Tennessee Valley Authority, 1101 Market Street, LP 5A, Chattanooga, Tennessee 37402-2801

NUCLEAR REGULATORY COMMISSION (NRC) – BELLEFONTE NUCLEAR
PLANT (BLN) – RESPONSE TO NRC INFORMATION NEEDS RELATED TO
ACCIDENTS, HEALTH PHYSICS, LAND USE, AND METEOROLOGY

Reference: Letter from Ashok Bhatnagar (TVA) to Mr. R. William Borchardt (NRC),
“Application for Combined License for BLN Units 3 and 4,” dated
October 30, 2007

**Area of Nonattainment for PM-2.5
in Jackson County
(Identified by U.S. Census Bureau
Block Group 01-071-9503-1)**

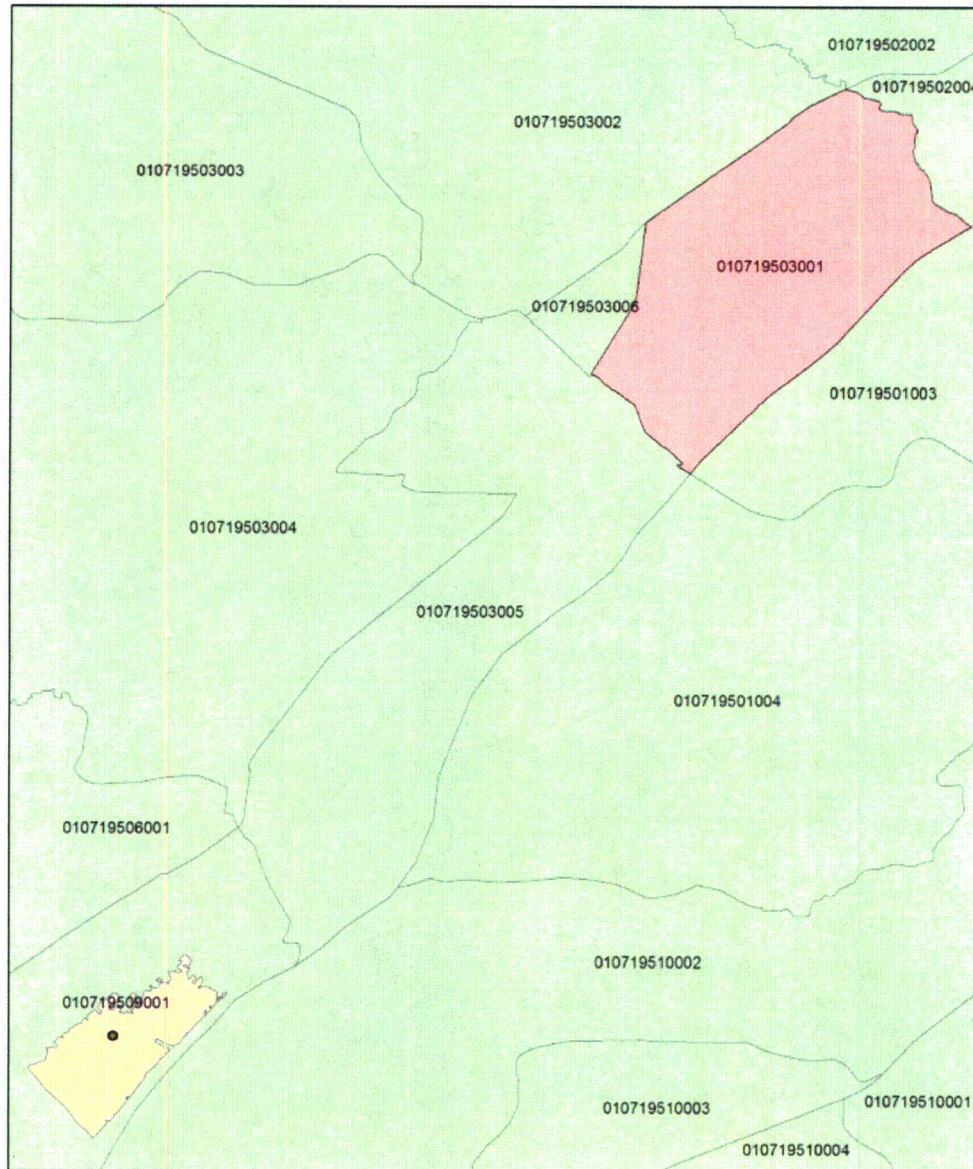
Need to meet with appropriate folks in the utility for ...2) addressing issues related to the site proximity to an air quality non-attainment area

During the week of March 31 through April 4, 2008, the NRC staff conducted an audit of the BLN site, including a review of the documentation supporting the BLN ER. The NRC meteorology reviewer requested additional information, including identification of the area in Jackson County that is in nonattainment. The Environmental Protection Agency identifies the nonattainment area in Jackson County as U.S. Census 2000 block group 01-071-9503-1 and stipulates that the area is in non-attainment for PM-2.5 (particulate matter with a diameter less than 2.5 micron). The non-attainment area is approximately 10 miles northeast of the BLN site boundary, as shown in the illustration provided as Attachment A to this enclosure.

The above classification of Jackson County as nonattainment for PM-2.5 is a result of being included in the AL-TN-GA area, which includes Chattanooga, Tennessee. The EPA identifies the PM-2.5 nonattainment area in Jackson County as U.S. Census 2000 block group 01-071-9503-1. Jackson County is part of the Tennessee River Valley (Alabama) – Cumberland Mountains (Tennessee) Interstate Air Quality Control Region. For Jackson County itself, the levels of all criteria pollutants are well within the EPA air quality standards for 2003 through 2005.
